# UNITED STATES PATENT AND TRADEMARK OFFICE

APPLICATION NO.	FILING DATE	FIRST NAMED INVENTOR	ATTORNEY DOCKET NO.	CONFIRMATION NO.
10/057,535	01/24/2002	Curtis White	BSC-159C1	3017

## Office Action Summary

FIG. 5F

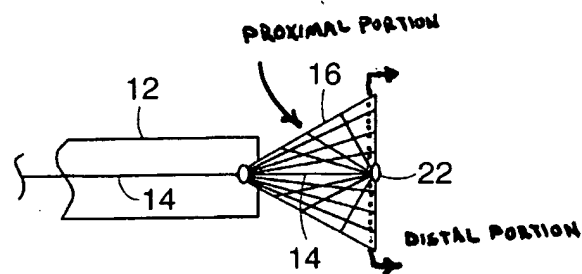
Claims 18, 23, 28, 30 and 33 are rejected under 35 U.S.C. 102(e) as being anticipated by Bates (U.S. 6,096,053). Bates teaches a medical retrieval device (Figs. 2 and 5F; See marked-up copy of Fig. 5F attached to this Office Action) comprising: a proximal handle 18; a sheath 12 extending from the handle 18 and including a lumen, the sheath 12 including a distal end away from the handle 18; a retrieval assembly 16 that is moveable relative to the sheath 12 to achieve a collapsed position of the retrieval assembly 16 within the lumen, the retrieval assembly 16 comprising: a proximal portion comprising a distal end and a three-dimensional shape when at least a portion of the retrieval assembly 16 extends out of the lumen from the distal end of the sheath 12; and a distal portion positioned at the distal end of the proximal portion, the distal portion comprising a flat shape perpendicular to a long axis of the device when the proximal portion extends from the distal end of the sheath 12; further comprising a guidewire 14 joined to a central portion 22 of the distal portion of the retrieval assembly; wherein axial movement of the guidewire 14 in a proximal direction collapses the distal portion of the retrieval assembly 16; wherein moving the sheath 12 in a distal direction causes the retrieval assembly 16 to collapse when it enters the lumen. Concerning the language of claim 23 requiring the distal portion of the retrieval assembly comprise a plurality of wires, one should note lines 23-39 of column 3 where Bates describes the construction of mesh portion 16 being of woven fibers or metal wires. Bates describes a method for
